SITE PLAN REVIEW AND APPEARANCE BOARD

CITY OF DELRAY BEACH

---STAFF REPORT---

MEETING DATE: December 16, 2015
ITEM: **Fourth and Fifth Delray** (aka iPic Theater) – Class V Site Plan, Landscape Plan, Architectural Elevations and Waivers Associated With The Construction Of A Commercial Project That Contains 7,487 square feet of retail, 42,446 square feet of office, and a 44,979 Square Feet Movie Theater Located South of Atlantic Avenue Between SE 5th Avenue and SW 4th Avenue.

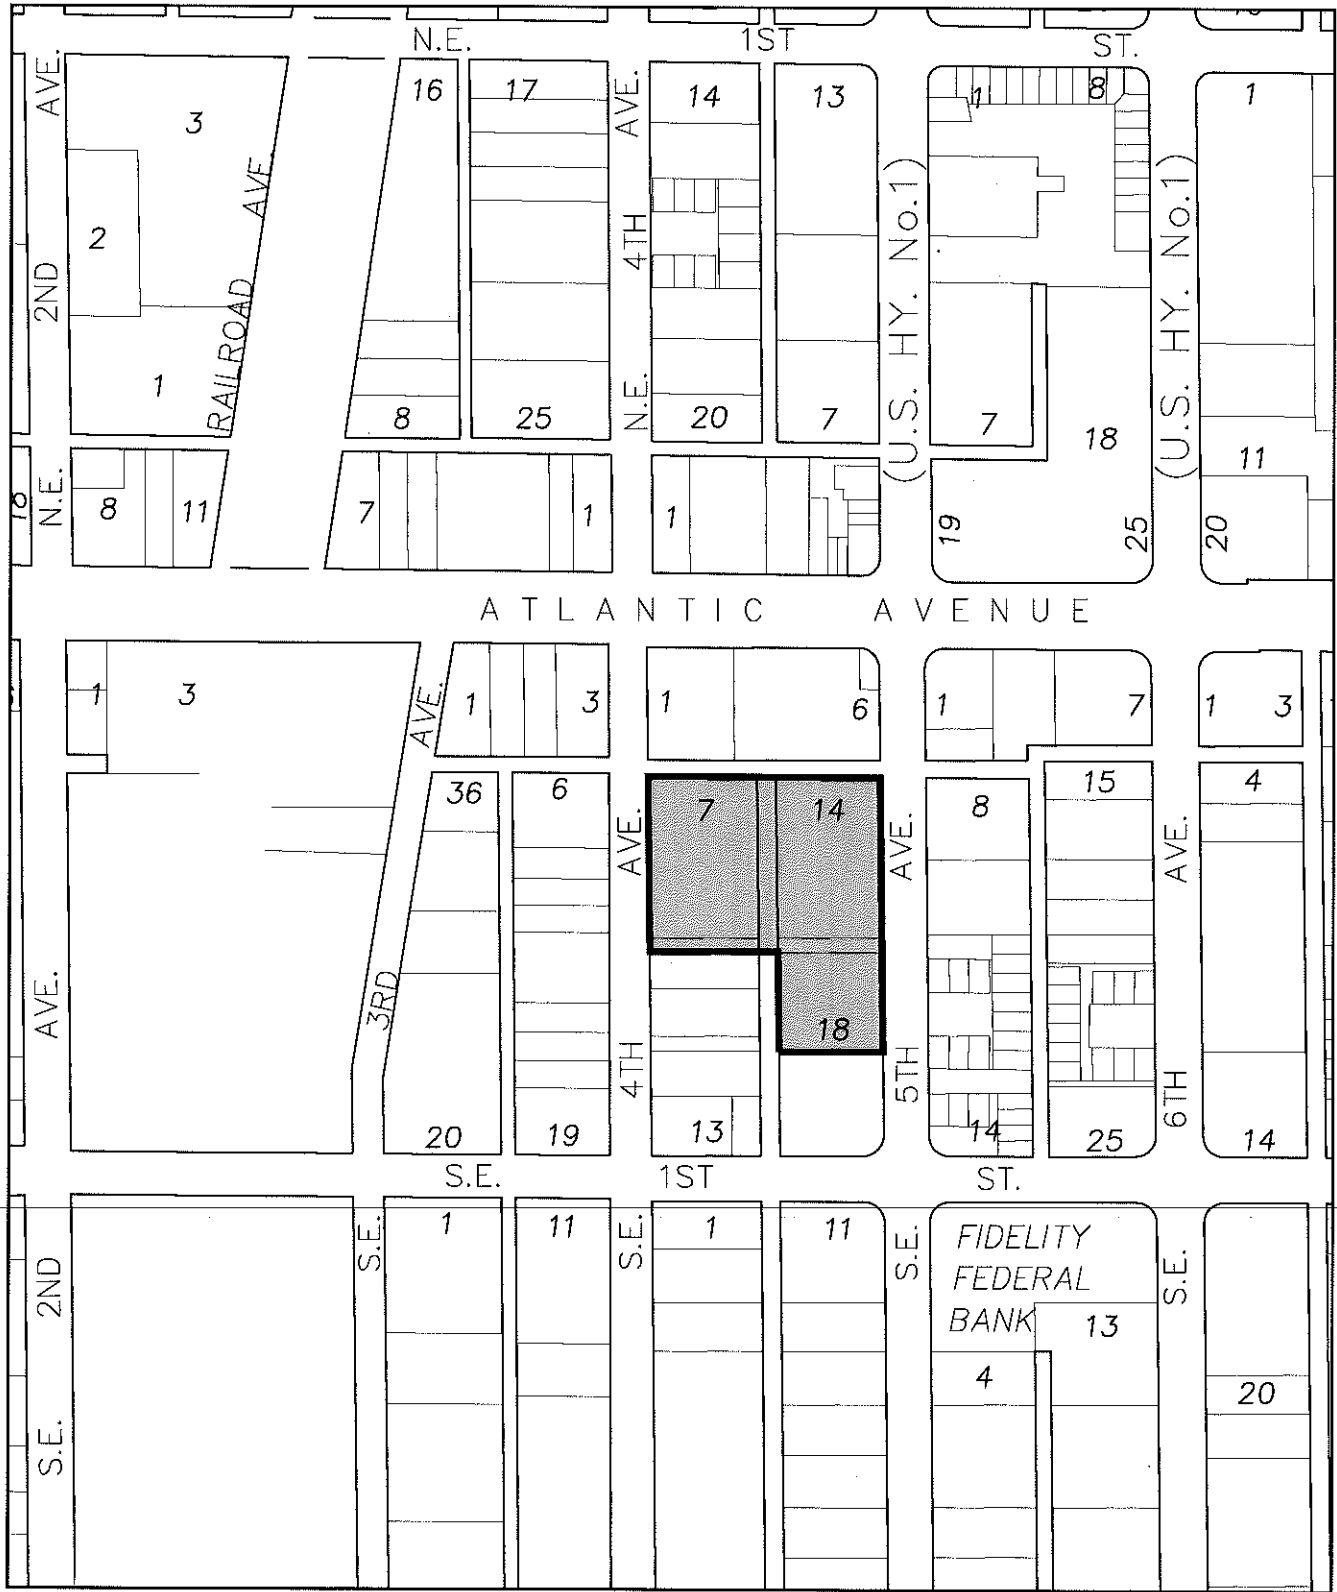
14. Accessible parking spaces for theater must be provided on the shortest accessible route not dispersed at different parking garage levels.
15. Provide Van parking count 1 per 6 required per 208.2.4 FBCA 2014

-
16. Provide verification of Occupancy classification and required type of construction with FBC 2014 and compliant with FBCA 2014 502 for design.
 17. Indicate inside turning radius of 25 feet in fire lanes for fire apparatus. Provide 48 foot outside turning radius in fire lanes for fire apparatus. *This must be noted at the turn near the theatre entrance and valet area.*
-
